UNITED STATES
NUCLEAR REGULATORY COMMISSION
WASHINGTON, D.C. 20555-0001

SUBJECT: CALVERT CLIFFS NUCLEAR POWER PLANT UNITS 1 AND 2 – FLOOD
HAZARD MITIGATION STRATEGIES ASSESSMENT (CAC NOS. MF7908 AND
MF7909)

STAFF ASSESSMENT BY THE OFFICE OF NUCLEAR REACTOR REGULATION
RELATED TO MITIGATION STRATEGIES FOR CALVERT CLIFFS NUCLEAR POWER
PLANT UNITS 1 AND 2 AS A RESULT OF
THE REEVALUATED FLOODING HAZARD NEAR-TERM TASK FORCE
RECOMMENDATION 2.1- FLOODING CAC NOS. MF7908 AND MF7909

Figure 3.1.1-1. Schematic of HEC-HMS model, taken from the Amended FHRR (Exelon, 2015).

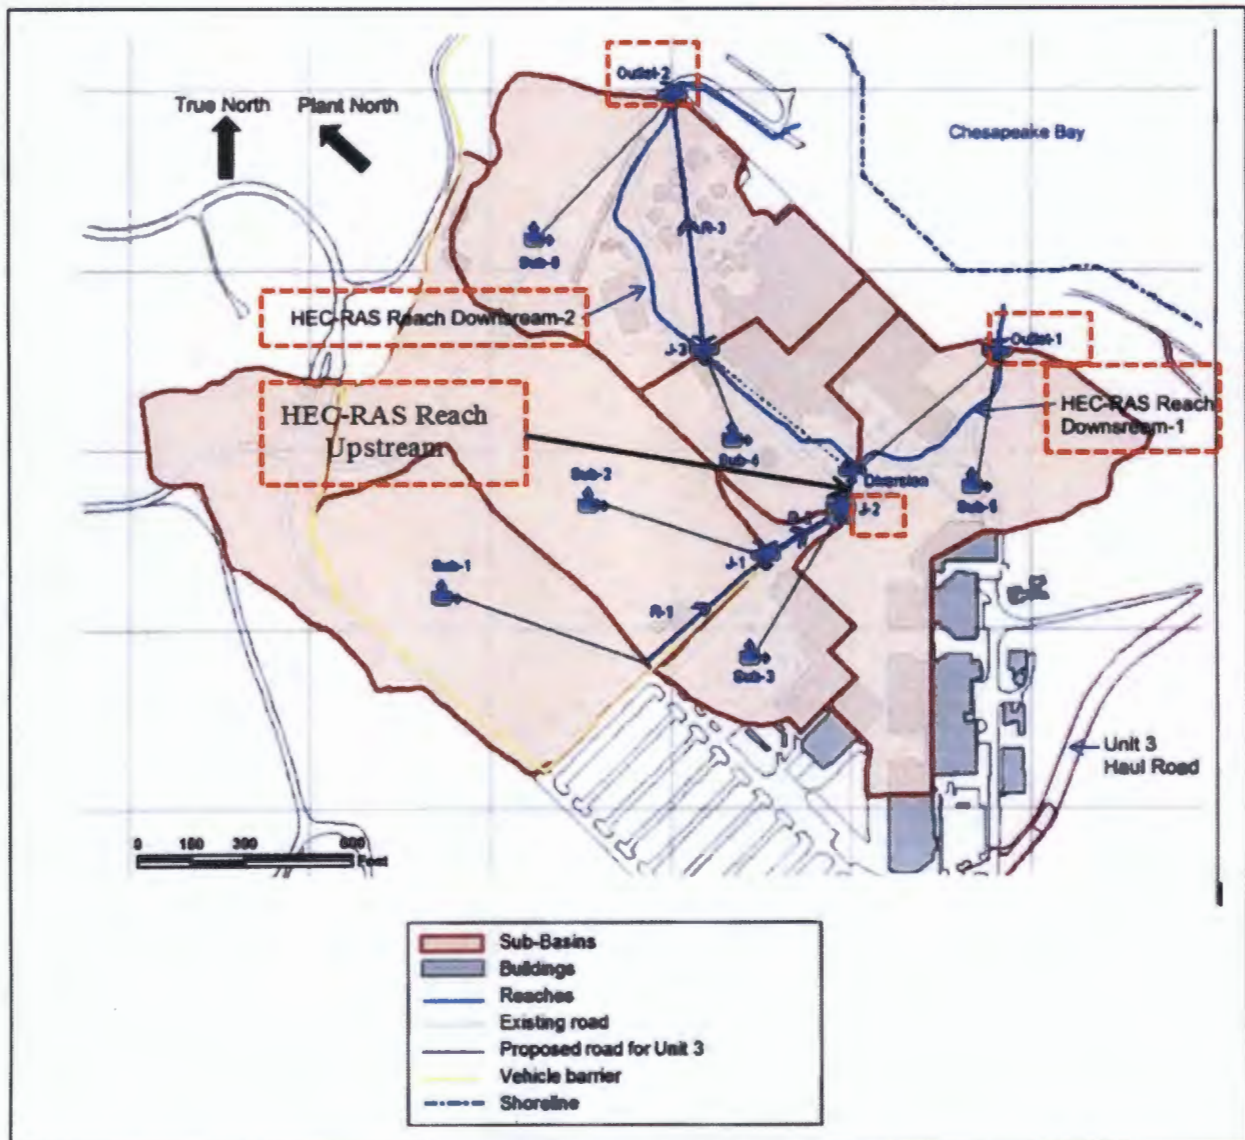
The licensee applied USACE-developed HEC-HMS and HEC-RAS models sequentially to evaluate the LIP flood hazard caused by a LIP flood-causing mechanism. They postulated a 6-hour ssPMP scenario as input to the Calvert Cliffs HEC-HMS model. That is, they distributed the 6-hour ssPMP value into 5-minute, 15-minute, 1-hour, 2-hour, 3-hour, and 6-hour intervals for input to the model (see Table 3.2.0-1). They used a front-peaking distribution in time. To set up the Calvert Cliffs HEC-HMS model, the licensee divided the onsite LIP basin into 6 subbasins and then linked the subbasins by channels as shown in Figure 3.1.1-1.

Figure 3.1.1-2. Schematic of the HEC-RAS hydraulic model for simulating the LIP flood-causing mechanism.

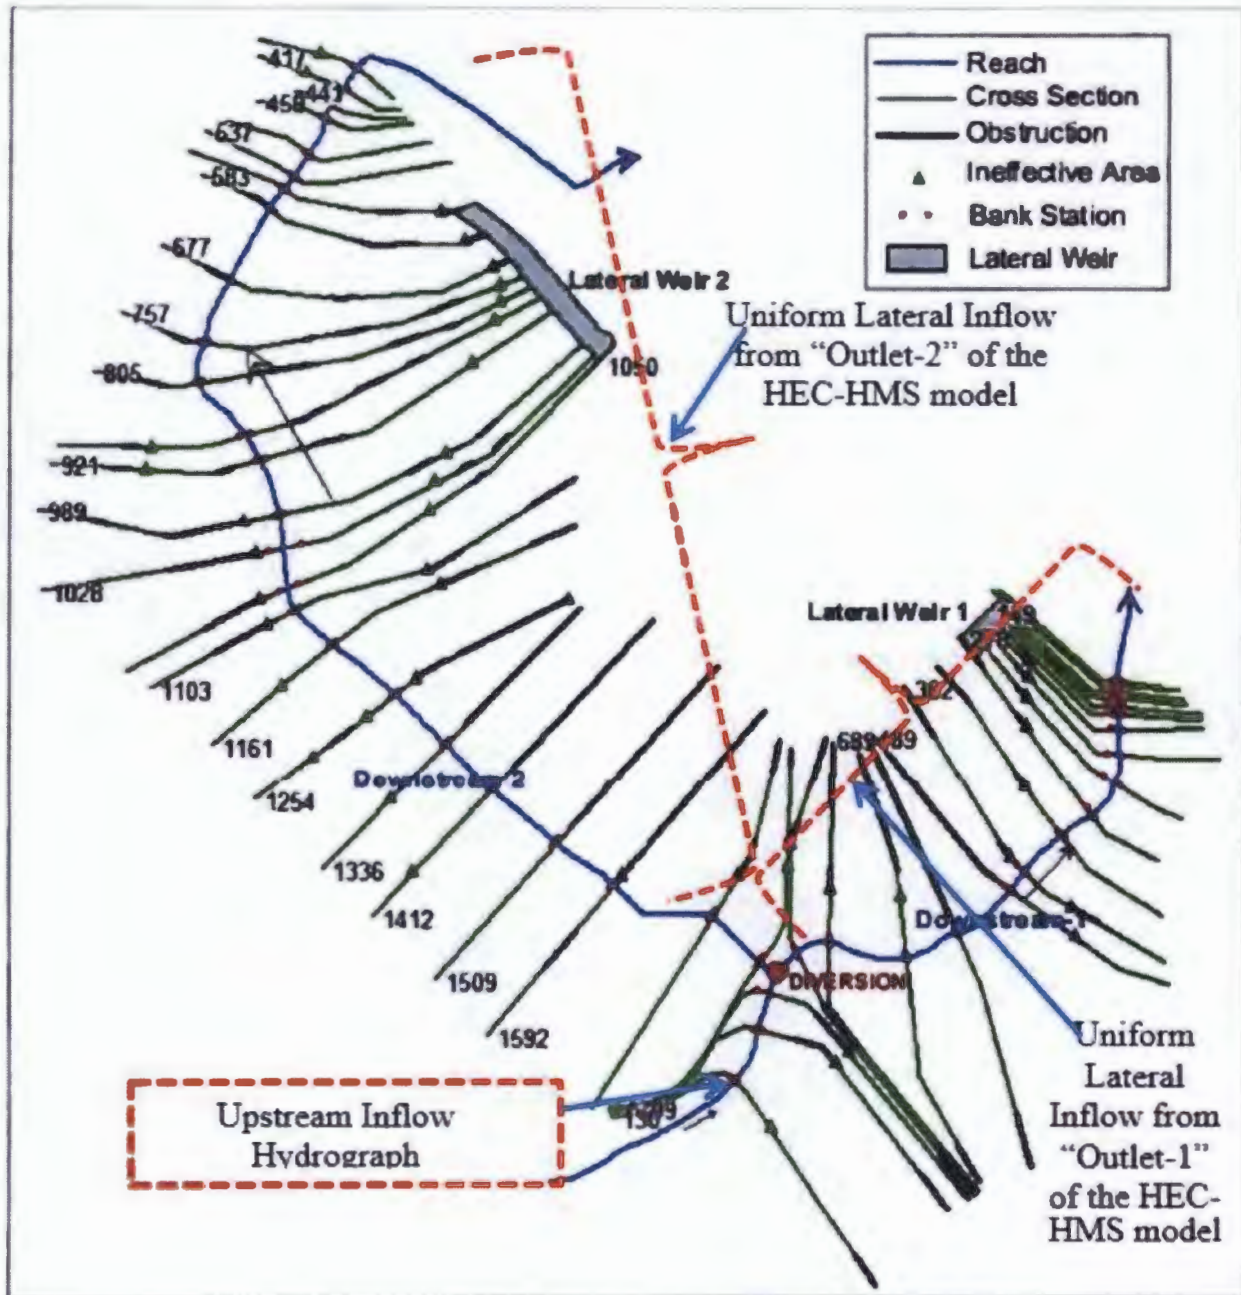
As described in its original FHRR, the licensee used the HEC-RAS model to route flood elevations at the Calvert Cliffs Units 1 and 2 power block area. The main features of the HEC-RAS are onsite drainage channels and cross-sections (see Figure 3.1.1-2). The licensee used the simulated outflow flow hydrographs from the HEC-HMS at locations, "J-2", "Outlet-1", and "Outlet-2" as upstream inflows to channels in HEC-RAS.

freeboards. The staff noted the maximum flood elevation in the vicinity of the power block area due to the LIP flood-causing mechanism is 45.5 ft. NGVD29, which is below the respective entrance elevation of 45.6 ft. NGVD29. The staff also noted the LIP flood with high velocity occurs only along the steep slopes within the Downstream-1 channel but not in the power block area.

Figure 3.1.2-3. Postulated PMH scenarios for (a) track direction (top) and (b) distance from the plant site to storm center (bottom) (from Exelon (2017)).

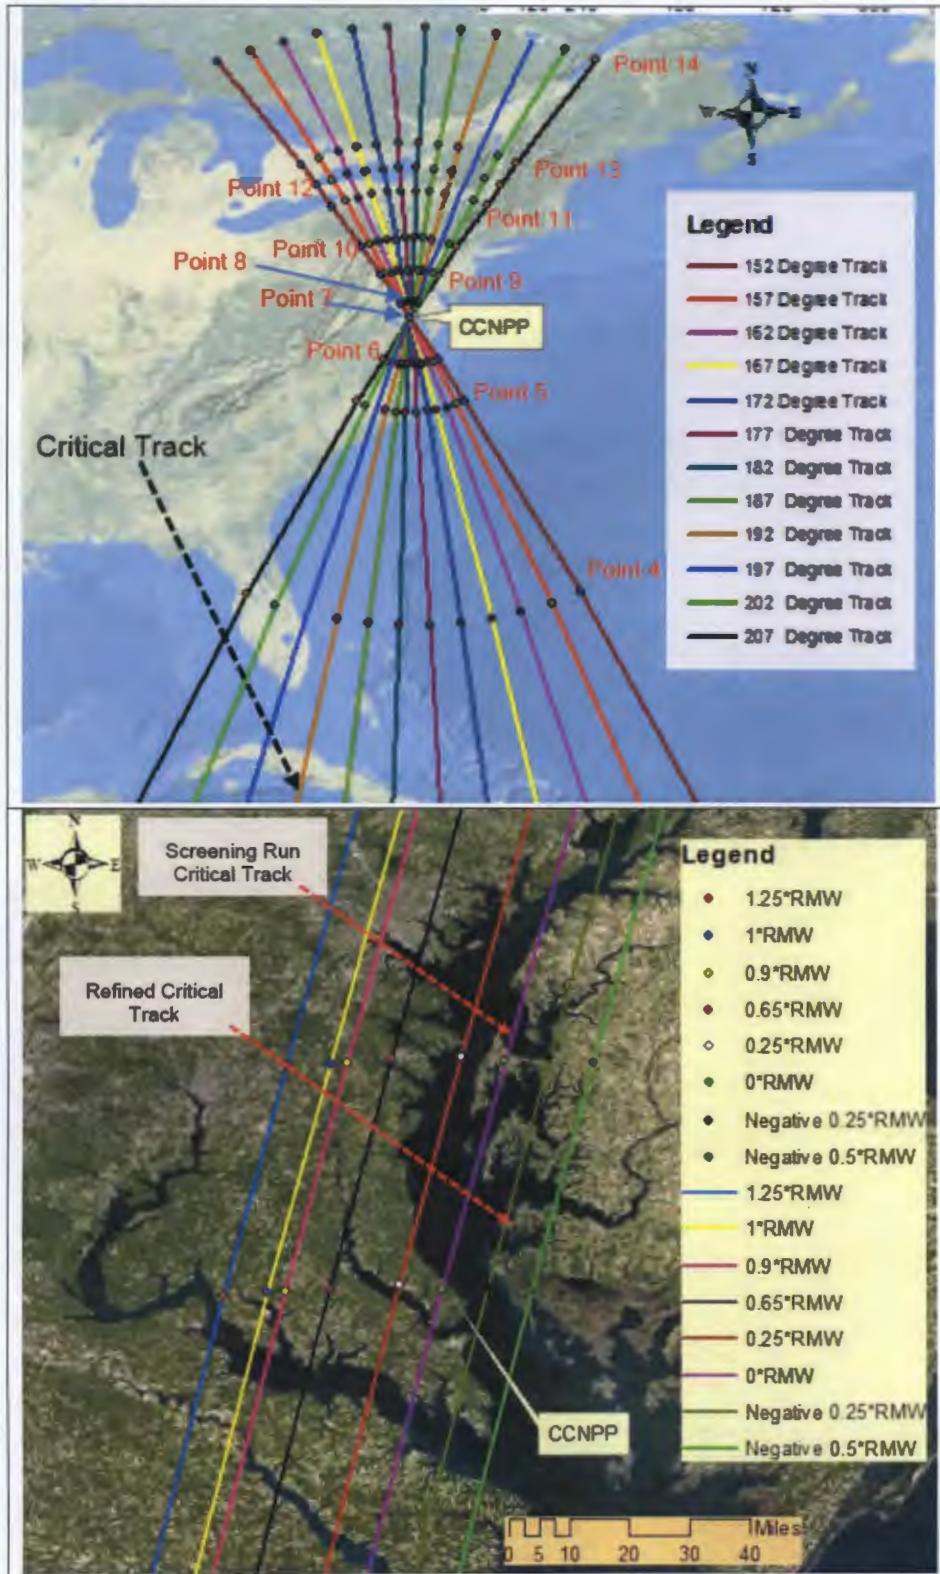
- i. Hold the pressure deficit of 123 milibar (mb) which is the maximum, and synchronize the timing of the storm surge with incoming high tide.
- ii. Simulate the Calvert Cliffs Delft 3D model with 10 track directions (152, 157, 162, 167, 172, 177, 182, 187, 192, and 197 degrees clockwise from the north) with an initial RMW of 26 nm, forward speed of 17 m/s, and center distance of zero from the plant site. From these sensitivity runs, the licensee identified the track direction of 192 degrees as it produces the maximum surge level (see Figures 3.1.2-3a and 3.1.2-4a).

- v. Simulate 8 center distances (1.25, 1.0, 0.65, 0.25, 0, -0.15, -0.5, -0.25 times RMW (see Figure 3.1.2-3b)), where positive value means storm center is shifted to the left from the site, while negative is to the right. The licensee selected -0.25 times RMW (0.25 times radii to the left) as an optimal (see Figures 3.1.2-3b and 3.1.2-4d).

Figure 3.1.2-4. Delft3D storm surge sensitivity for (a) track direction for top-left, (b) RMW for top-right (c) forward speed for bottom-left, and (d) storm track for bottom right (from Exelon(2017)).

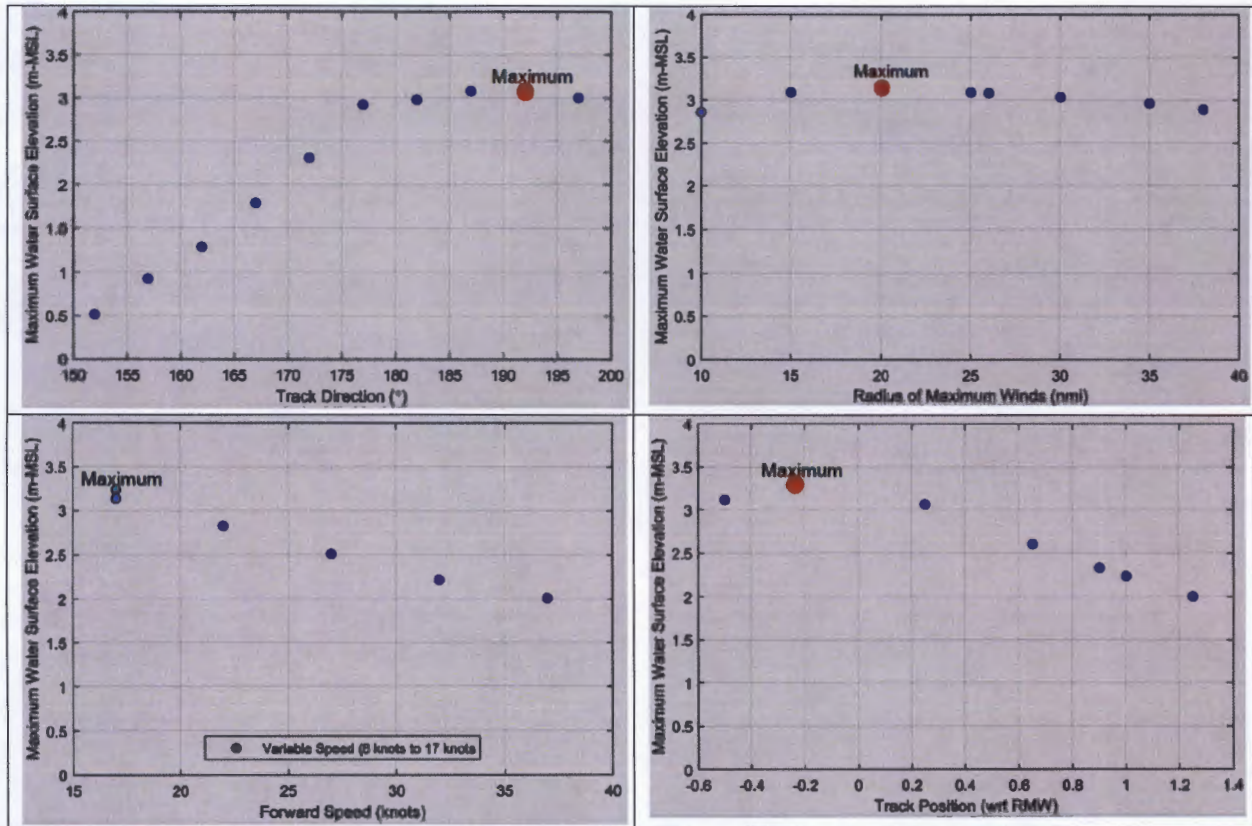
- iii. Simulate the model with 8 RMWs (10, 15, 20, 25, 26, 30, 35, 38 nautical miles (nm)) with the storm direction of 192 degree, forward speed of 17 m/s, and center distance of zero. The radius of maximum wind sensitivity was extended beyond the range presented in NWS 23 to determine if hurricanes with larger RMWs increase the surge level at the plant site. From these runs, the licensee determined an optimal RMW of 20 nm (see Figure 3.1.2-4b).

- iv. Simulate the model with 6 storm forward speeds (17, 22, 27, 32, 37, and variable speed of 8 and 17 knots (kt)) with the storm direction of 192 degree, RMW of 20 nm, and center distance of zero. The licensee-identified combined forward speeds of 8 kt before landing and 17 kt after landing turned out to be optimal (see Figure 3.1.2-4c).

Table 3.1.2-1 lists the licensee-provided optimal PMH parameter values from the resulting of the screening. Figure 3.1.2-4 displays the results of the sensitivity analysis, where each plot forms clear surge level peaking for most of the parameters. As the rates of changes at the peak are insignificant (e.g., mostly less than a foot), the staff determined the discrete parameter intervals used in the licensee's screening is acceptable without further refining the parameter values at finer discrete intervals. In particular, the staff noted onsite surge level is less sensitive to the change of RMW values compared to those at open coastal sites. The staff believes this is due to the breaking and attenuation of offshore surge and wave, as the plant site is located approximately 80 miles inside from the mouth of the Chesapeake Bay.

The staff also noted the licensee's selection of 20 nm RMW storm is based on a single "base" track that goes over site, even though it is within the range provided by NWS 23. That is, the sensitivity to RMW parameter was not checked for multiple storm tracks, angles, and landing locations. For example, the licensee settled on the 20 nm RMW value with a simple track (landfall and angle) that may not produce the maximum water level at the plant site. The staff also recognized the screening could be improved further by refining the PMH parameter values, such as using RMW values at the 1nm resolution or track positions at the finer (e.g., 0.1 times RMW) resolution. These refinements would end up a higher surge level estimates than the ones presented by the licensee in the amended FHRR. To resolve this issue, the staff found from Figure 3.1.2-4 that the change of surge level at or near optimal RMW (e.g., 20 nm) is small for those initial "base" runs (e.g., much less than one foot per discrete interval tried), and that the same is true for other PMH parameters. Therefore, the staff determined the result of the licensee's screening is acceptable without further refining the parameter intervals. In all, the staff concludes the screening process to obtain site-specific PMH parameters is reasonable and the resulting PMH parameters are acceptable for use in the MSA as the licensee followed a hierarchical approach recommended by the guideline provided in NUREG/CR-7046 Appendix E (NRC, 2011).

Figure 3.1.2-7. Cross Section Schematic of Wave Activity on Pump House at Calvert Cliffs Units I and 2 House (from the amended FHRR, Figure 2.4-32).

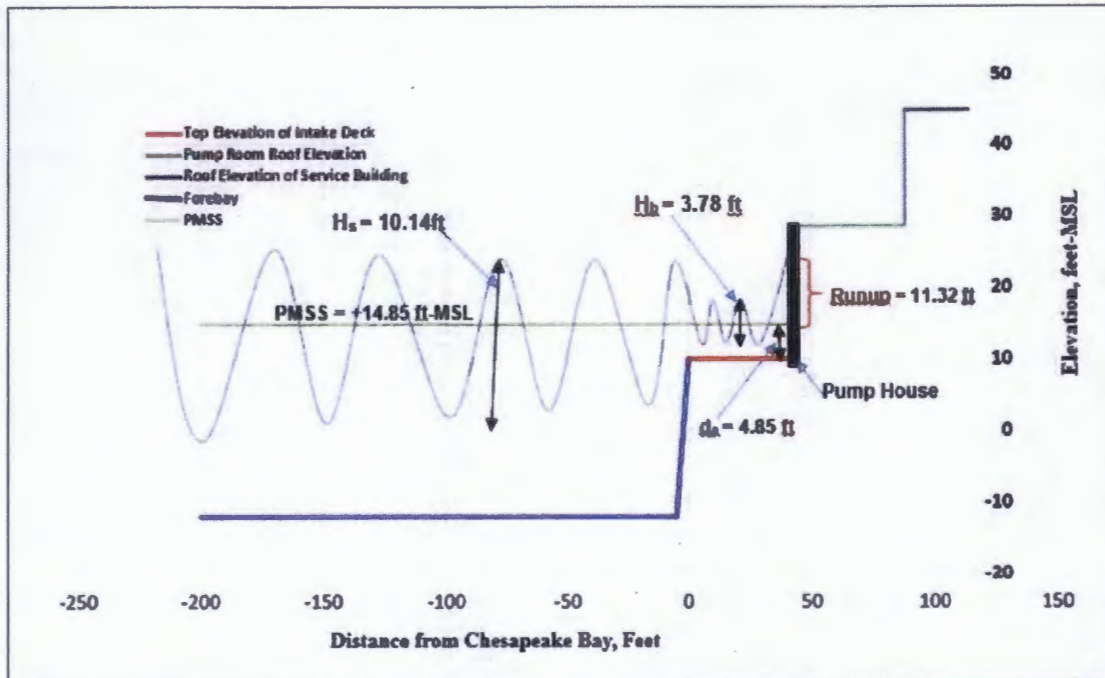
The licensee estimated storm surge-induced wave runup at the Units 1 and 2 Intake Structure (Exelon, 2015). The licensee assumed that runup occurs when wind-generated wave moves over the top of the intake deck and hits the front wall of the Intake (see Figure 3.1.2-7). They determined the controlling depth of water on the deck is 4.85 ft. The controlling depth limits the wave height over the deck as the break of large waves may occur in front of the deck. The licensee determined a maximum wave height after break is equal to 3.78 ft. using a depth limiting constant of 0.78 (Exelon, 2015). The licensee estimated runup values using the following two methods described in Army Corps of Engineering (USACE) Coastal Engineering Manual (CEM) (USACE, 2011):

The licensee then selected the runup value of 11.32 ft. conservatively (Exelon, 2015). This runup estimate is for the 2 percent exceedance maximum wave runup as indicated by CEM Equation VI-5-7 (USACE, 2011). The NRC staff examined the licensee's methods and conditions for the wave runup on the step-like intake structure. The staff confirmed the methods and conditions used by the licensee to estimate runup is reasonable and the runup estimates

For the equivalent slope method, the staff assumed the step-like intake deck cross section from the toe of the deck to intake wall is idealized as an impermeable slope. With the deck height of 10 ft. and length to the wave direction of 50 ft., the staff estimated an equivalent slope of 17.2 degree using the guideline provided by the CEM (USACE, 2011). The staff's independent calculations demonstrates that the licensee-estimated wave runup values are within the range of the staff's values even though the licensee used different runup conditions and exceedance probability level. Therefore, the staff concludes the licensee's runup estimate is acceptable for use in the MSA as they followed the guidelines provided by USACE (2011).
